RE: Evoke McDowall CTS 54820 - Submission on Development Application A006943953 – Multiple Dwelling (27 Units), 61 Landis Street, McDowall QLD 4053

RE: Submission on Development Application A006943953 – Multiple Dwelling (27 Units), 61 Landis Street, McDowall QLD 4053

Figure 4: Extract from the applicant's revised site plan showing the driveway access on Landis Street at the northwestern corner, immediately adjacent to the 67 Landis Street boundary.

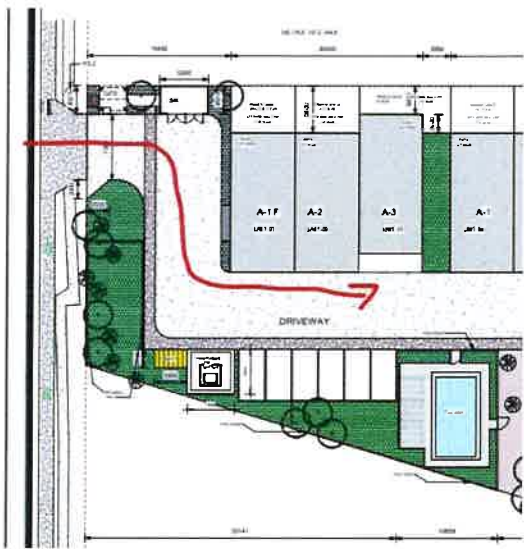
The driveway access to the proposed development is located on Landis Street at the northwestern corner of the site, immediately adjacent to the body corporate's shared boundary. As shown in Figure 4, vehicles enter from Landis Street at this northern point and turn east into the internal driveway running through the development.

All vehicle movements into and out of a 27-dwelling development, including at night and early morning, will occur at the point closest to the body corporate's common property. The amenity impacts on residents of Evoke McDowall from vehicle headlights, engine noise, and manoeuvring activity at this location have not been assessed. The body corporate requests that Council require a specific amenity impact assessment addressing the driveway location before any decision is made.
